G.O. No. B.P. No.	4151 W.	Press. Mis.
Dated	26-10-1878	~~197~~.

26th October 1878, No. 4,151 W.

Deputy Tahsildar's Cutcherry, Venkatagiri, Nellore.—The plan and estimate of Rupees 370 for alterations to the — sanctioned.

Deputy Tahsildar's Cutcherry, New,—at Venkatagiri, in Nellore District.—Submitting for sanction of Government through Inspector-General of Police, Collector's recommendation for making certain alteration in — with a view to the safe custody of the cash-chest.

ENCLOSURE No. 2.—Sketch.

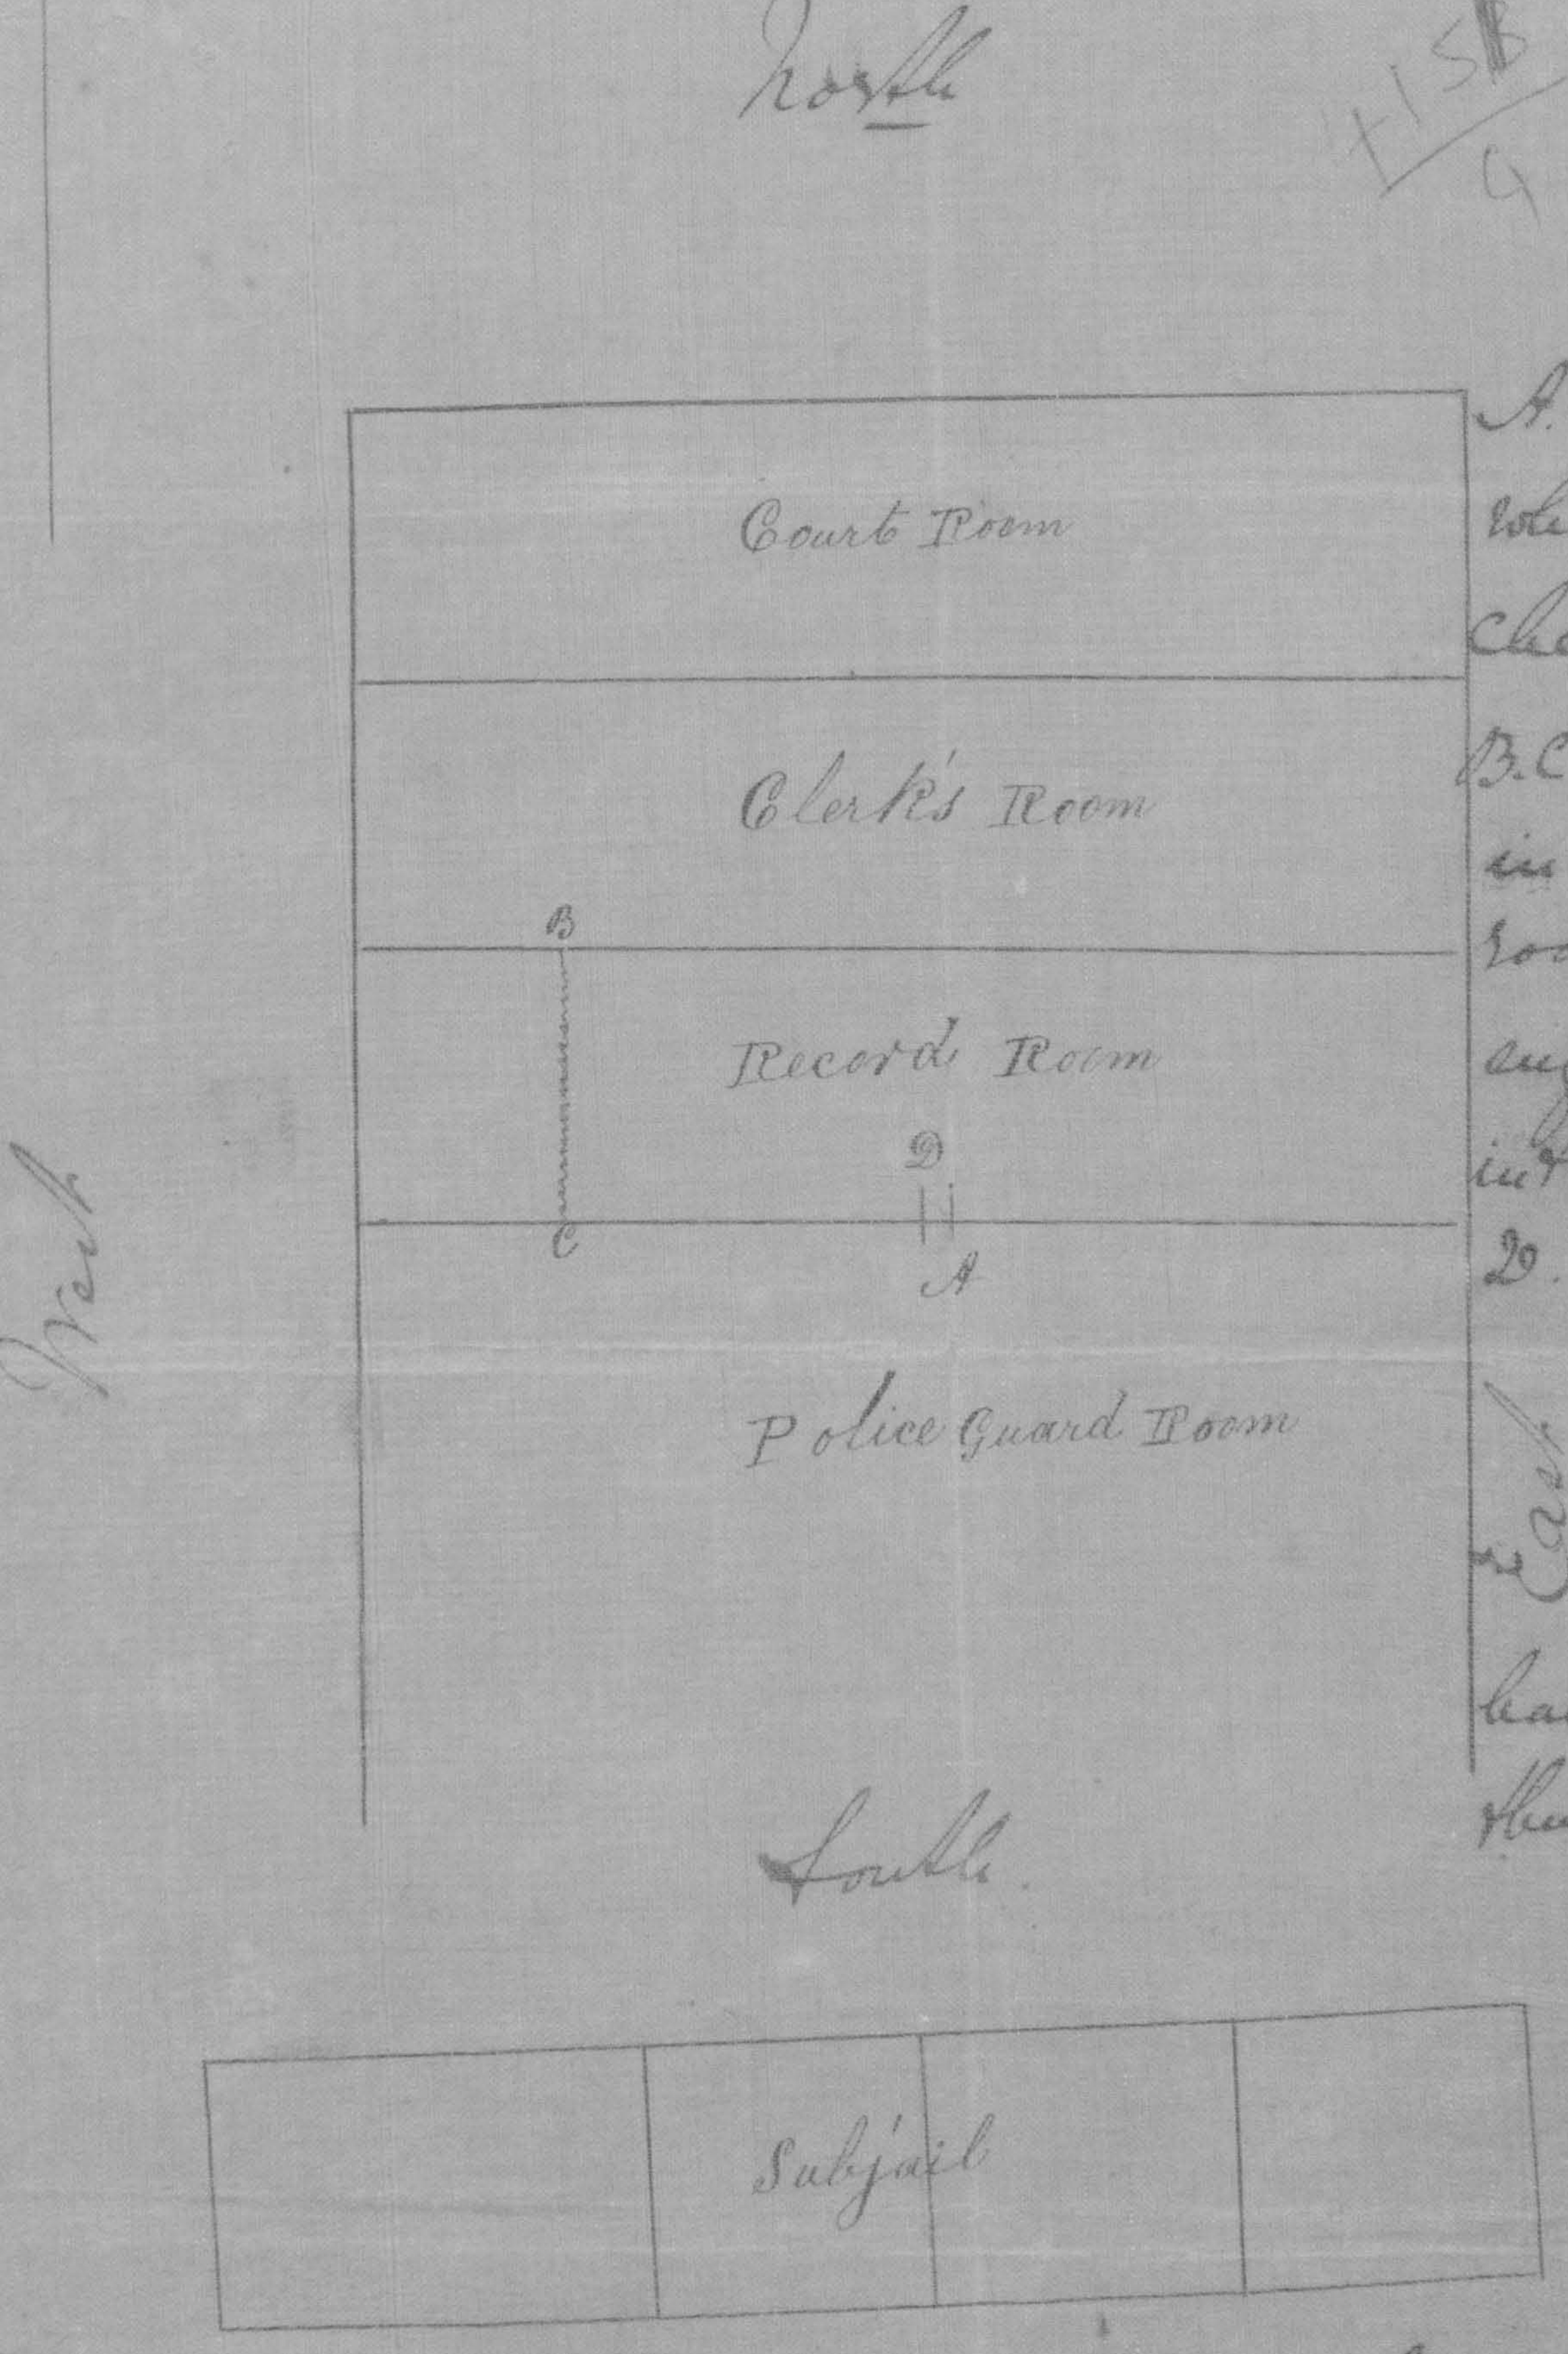
5. Should it please your Honor, I beg to suggest that iron gratings may be had to enclose a space for the cash-chest in the Police guard-room. Better it would be and safer also, to keep the cash-chest in the record-room with iron gratings as marked B, C, and with a window at D in the southern wall of the record-room. By this arrangement the cash-chest is not only out of the sight of everybody, but is also safe within the walls of the room. The Police can equally have a watch over it through the window with iron gratings.

A. The place where the Cash chest is now placed

B.C. The place in the record room where it is suggested to keep in the chest.

D. The window in the record room through which the Police can have guard from their room.

In forwarding the enclosed Proceedings x of the Board of Revenue together with a plan of the Deputy Tahsildar's Cutcherry at Vencatagiri in the Nellore District I have the honor to State that I think it would be a very good plan to keep the Cash Chest in the Record Room as proposed by the Deputy Tahsildar - I do not understand however how the Cash Chest within gratings B & C can be in view of a sentry outside the iron barred window

window D unless the Sentry can see round a Corner - The Super=intendent of Police suggests that there should be an iron barred doorway at D within which the Cash Chest might be placed in full view of the Sentry - This plan seems to me preferable -

The arrangement consists of an iron cage 6' Square in the record room in which the cash chest is to be placed, with an iron barred door leading from it into the Police guard room. The doors BB of the record room to be walled

up, the venetian door at C to be removed and replaced by an iron barred door. The shutting up of the doors B B will give greater space and Security; the iron bar doors at A, C will give sufficient light for the business of the record room.
